Appeal Decision

Appeal Ref: APP/R5510/W/19/3232504

Land adjoining 1a Nicholls Avenue, Hillingdon, UB8 3JL

Item No.	Report of the Head of Planning, Transportation and Regeneration
Address	LAND ADJACENT TO 1A NICHOLLS AVENUE HILLINGDON
Development:	Two storey building comprising of 2 x 1-bed and 1 x 2-bed self-contained flats with associated parking and amenity space and detached double garage to rear.
LBH Ref Nos:	54817/APP/2018/4476
Drawing Nos:	02_A 57_B 58_B 59_B 01_A 03_A 04_A 05_A 50_B 51_B 54_B 55_B 56_B 60_A 52_B 53_B

Drawing Title
Proposed Site Elevations

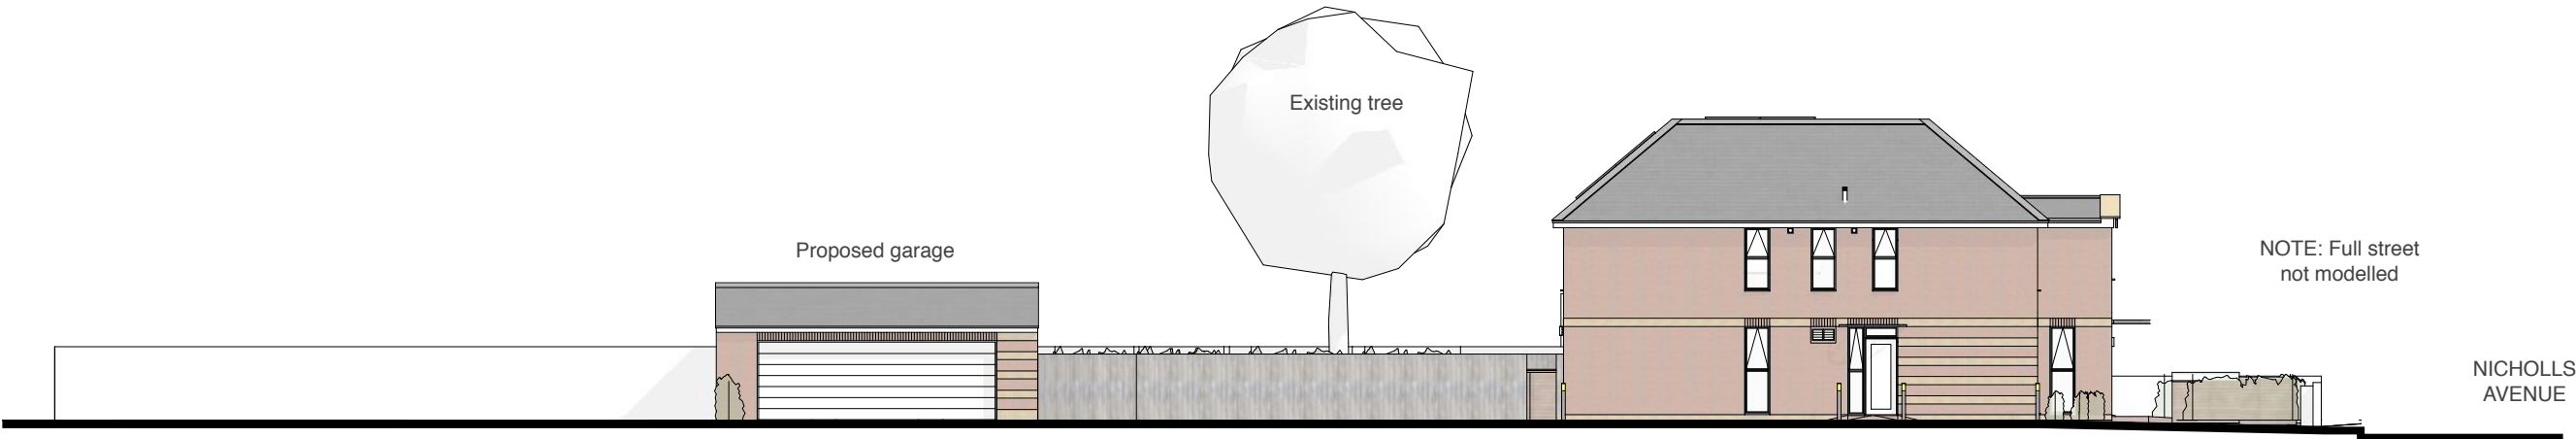
6. The two-storey projection to the front, with its squat roof, and the crown roof to the main building, are not characteristic of the adjacent development or surrounding area. They result in the building having a substantial, bulky and imposing appearance. Considering this and the proximity of the building to the front boundary it would be a dominant and incongruous addition within the streetscene.

- 1 · The overall scale of the proposed building along with its crown roofed design and conflicting shallow pitched roof to the front projection would fail to respect the development within the immediate vicinity and would represent an incongruous addition and form of development detrimental to the visual amenities of the street scene therefore failing to harmonise with the established character of the surrounding area. The proposal is therefore contrary to Policy BE1 of the Hillingdon Local Plan (November 2012), Policies BE13 and BE19 of the adopted Hillingdon Unitary Development Plan Saved Policies (September 2007) and section 4.23 of the Council's HDAS (SPD): 'Residential Layouts'.
